# UNITED STATES PATENT AND TRADEMARK OFFICE

10/587,673

<b>Office Action Summary</b>	<b>Application No.</b> 10/587,673	<b>Applicant(s)</b> DAMSON ET AL.	
	<b>Examiner</b> ANNA MOMPER	<b>Art Unit</b> 3657

## **DETAILED ACTION**

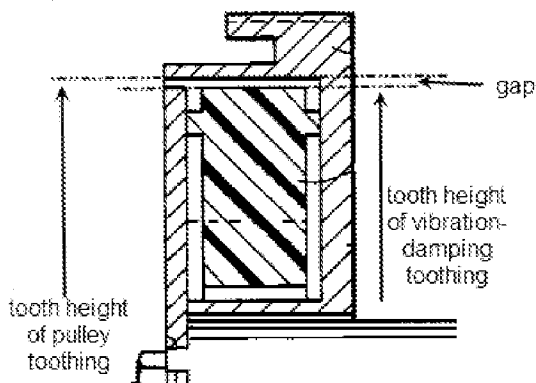
element 10 is disposed between the outer peripheral surface and the hub and has tooth elements 10b which engage with tothing of the pulley. This vibration-damping element 10 can be seen in the pulley assembly cross sectional view of Fig. 1 wherein a gap can be seen between the radially outermost surface of the vibration-damping element 10 and the radially innermost surface of the outer pulley rim. As the height of the pulley tooth extends from the radially innermost surface of the outer pulley rim to the outer peripheral surface of the hub, and the height of the vibration-damping element tothing extends from the outer peripheral surface of the hub to the outer peripheral surface of the vibration damping element with a gap between the outer peripheral surface of the vibration damping element and the inner peripheral surface of the outer pulley rim, the tooth height of the vibration-damping element must be less than that of the pulley tothing (see rejection below).

at least one vibration-damping element (10) located between the pulley and the hub (Fig. 1, Fig. 2),

wherein the vibration-damping element (10) is rigidly connected at its inner circumference with the hub (11) and is engaged at its outer circumference with the pulley (6, Col. 3, Ln. 4-7, Ln. 44-48, Ln. 60-68, the vibration-damping element engages with pulley 6 through recesses 10C for receiving arms 9 of pulley 6, the vibrating-damping element has recesses 10D allowing it to be rigidly connected to hub 11 through projections 11A),

wherein the vibration-damping element (10) has an outer toothing (10B) that is engaged with an inner toothing (9) on the pulley (6, Col. 3, Ln. 1-6), and

wherein a tooth height of teeth of the inner toothing (9) of the pulley is greater in every operating state than the tooth height of teeth of the outer toothing (10B) of the vibration-damping element (see fig. below, there is a gap between the outer toothing of the vibration-damping element resulting in a tooth height of the outer toothing of the vibration-damping element being less than that of the inner toothing of the pulley).
